Date: April 18, 2019
To: Planning Board
From: Lincoln Daley, Community Development Director
Subject: SD2019-01 - Richard Keogh, Tax Map 23, Lot 2, 118 Amherst Street. Major Subdivision Plan – Design Review proposal to subdivide the subject parcel into nine (9) total lots, the construction of an 820’ linear foot subdivision roadway, and related drainage/stormwater improvements.

DESIGN REVIEW SUBDIVISION PLAN
LAND OF:
RICHARD N. KEOGH
TAX MAP 23 LOT 2
MILFORD, NEW HAMPSHIRE
SCALE: 1" = 60'
FEBRUARY 25, 2019

**Re: Interdepartmental Review Map 23 Lot 2
Major Subdivision - Keogh**

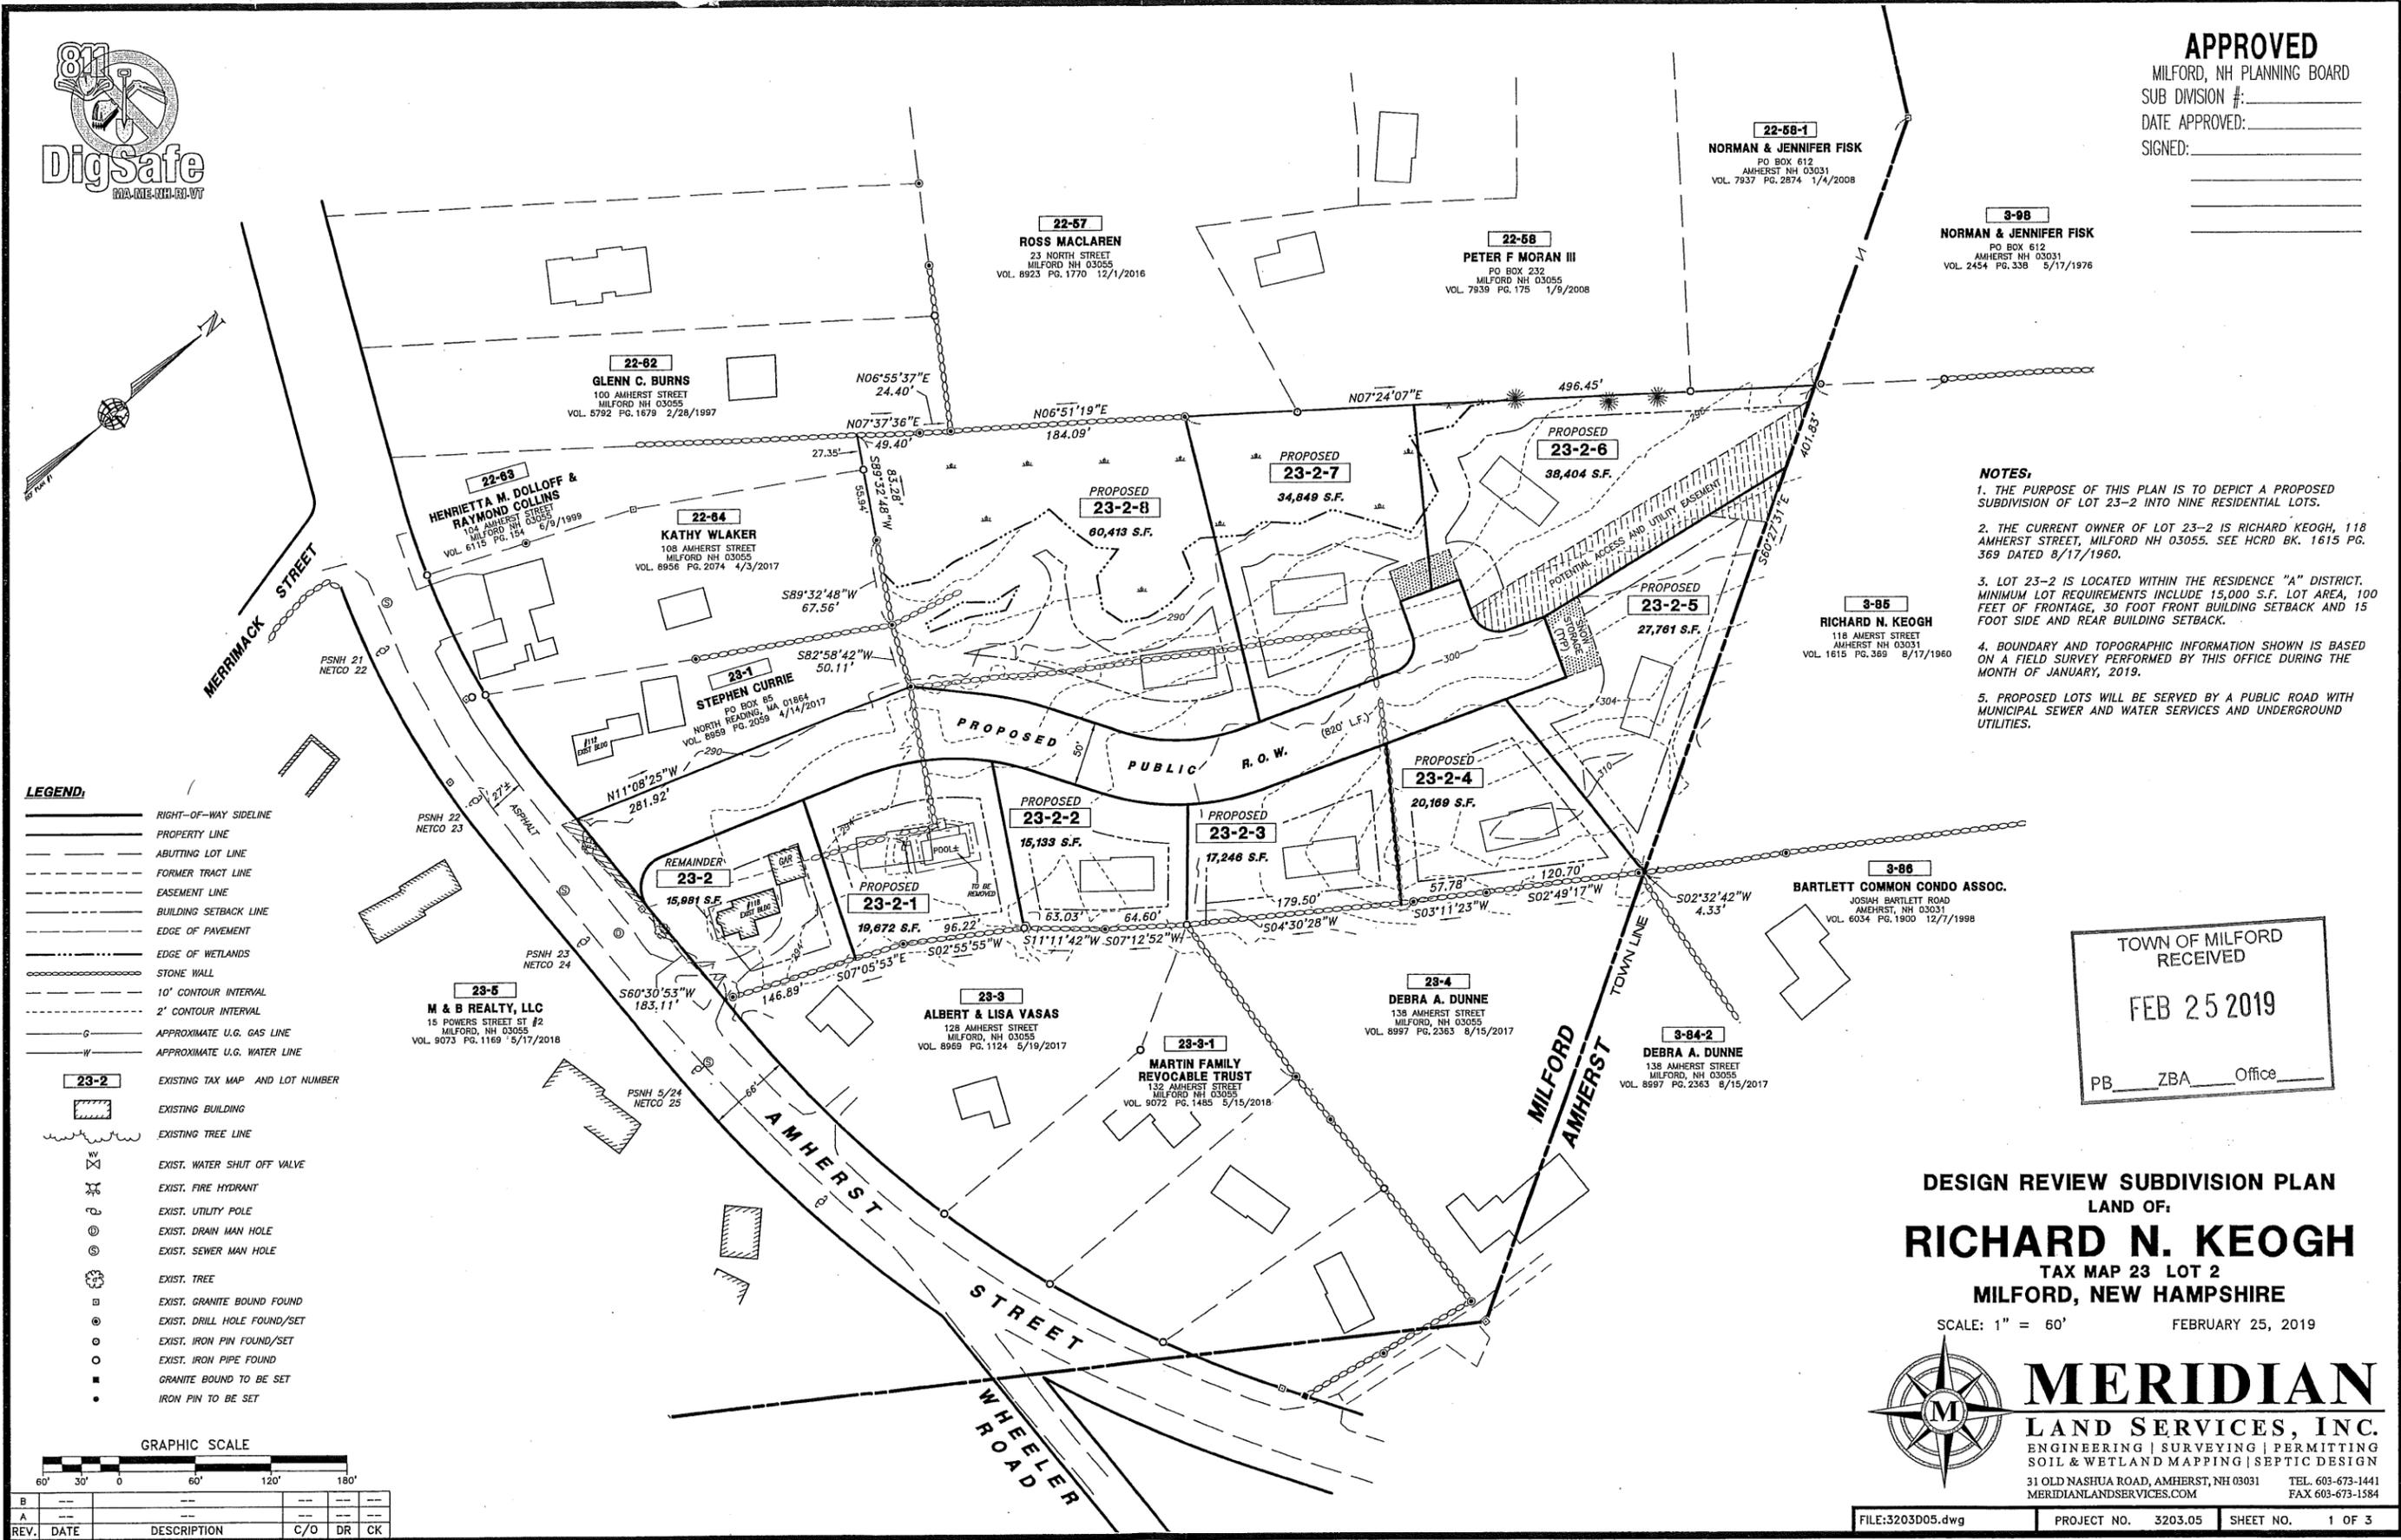
Based on the design and layout, the applicant is proposing a 9 lot conventional subdivision design. As stated previously, each of the proposed lots meet the minimum 15,000 square feet and 100 linear feet of frontage. Staff questions the viability of Map 23, Lot 2-8 given the limited building envelope due the extent of the delineated wetland resources areas and location of a detention basin within what appears to be feet from the residential house. The applicant should discuss and further clarify how this lot satisfies the purpose and intent of development regulations by providing for the safe, attractive and harmonious development of land and to insure the health, safety and welfare of the residents of the Town of Milford.

In addition, the accessory structure shown on Map 23, Lot 2-2 associated with the existing house, appears to encroach upon the 30 foot front setback (new subdivision road) and 15 foot side setback and thus would require a Special Exception. The density is based on the number of lots which could be laid out in a conventional subdivision without the need to obtain variances, special exceptions, and/or waivers for lot frontage, setbacks, area, road and driveway grades. The applicant should clarify or consider revising the plan.

The stormwater management design has not been submitted as part this application. The plan displays a detention basin on southern side of the proposed Map 23, Lot 2-8.

Heritage Commission: Several concerns over the number of stone walls that will be disturbed in the proposed roadway and particularly in lots 23-2-1 and 23-2-8. Noting the large amount of recontouring of the slope, there would be much disruption of the walls. The Committee would like to see some alternative plans that would preserve most of the walls as this is a well-documented feature of the town's heritage speaking to the early farming use of the land going back to our earliest settlers. There were also comments as to plans for sidewalks in the plan.

1. The plans display several existing stone walls on the property. The applicant is encouraged to reuse and incorporate the stone into the subdivision design and layout.

2. The snow storage areas shown at the ends of the subdivision roadway turnaround are located outside of the proposed Right of Way and would require the access/maintenance easements to store and maintain snow on private property.

3. Driveways located off of the ends of the turnaround areas of the proposed roadway are strongly discouraged (see lots 23-2-6 and 23-2-5).
4. Please provide the total buildable enveloped for Map 23, Lot 2-8 subtracting the wetland resource areas, buffers, and the detention basin.

2. The Conservation Commission requests that no house lots be created that contain wetlands or their associated buffer. This request would result in the removal of lots 23-2-7 & 8 or make all the lots smaller to keep the number of lots.
